ET 13-0024

Subject: Docket No. 50-482: Response to Request for Additional Information Regarding License Amendment Request to Revise Technical Specification (TS) 3.8.1, "AC Sources - Operating" Surveillance Requirement 3.8.1.10

### Response to Request for Additional Information

Figure 4  
 Single-Load Rejection Test (followed by ESW pump start)  
 (Page 1 of 1)

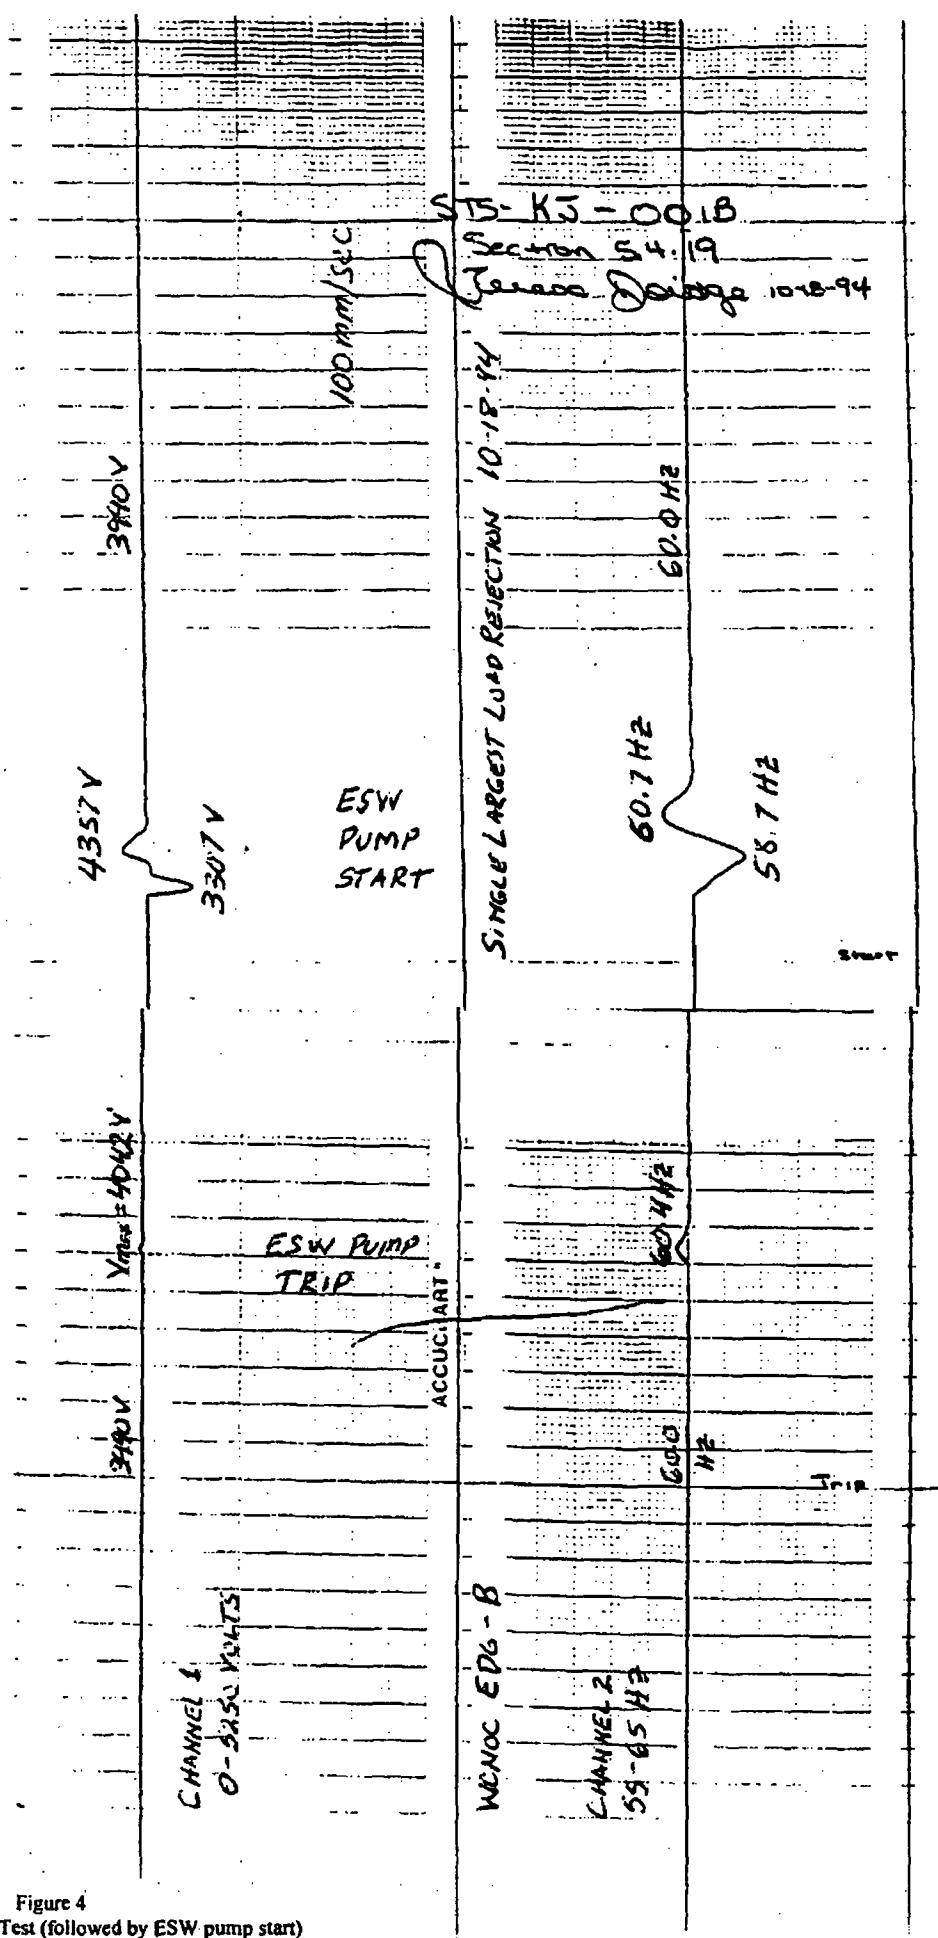
*In the event that the DGs are supplying the safety-related buses and a large load rejection event occurs, please discuss how the operating equipment on the safety-related buses will not be degraded if the DG output voltage spikes to 4992 V.*

**Response:** The essential service water (ESW) pump motors are 1750 Hp and are the single largest load associated with the DG. License Amendment No. 101 (Reference 3) approved the deletion of the single-load rejection surveillance test. During the review of the license amendment request, WCNOG responded to a request for additional information (Reference 4) and provided information associated with the voltage swing during the single-load rejection test. From Reference 4, WCNOG concluded that the voltage and frequency swings for the single-load rejection test stay within steady state values during the transient. The Enclosure provides Figure 4 (from Reference 4) that shows a recording of voltage and frequency during a single-load rejection test (pump trip followed by a pump start). The NRC safety evaluation (Reference 3) concluded, in part:
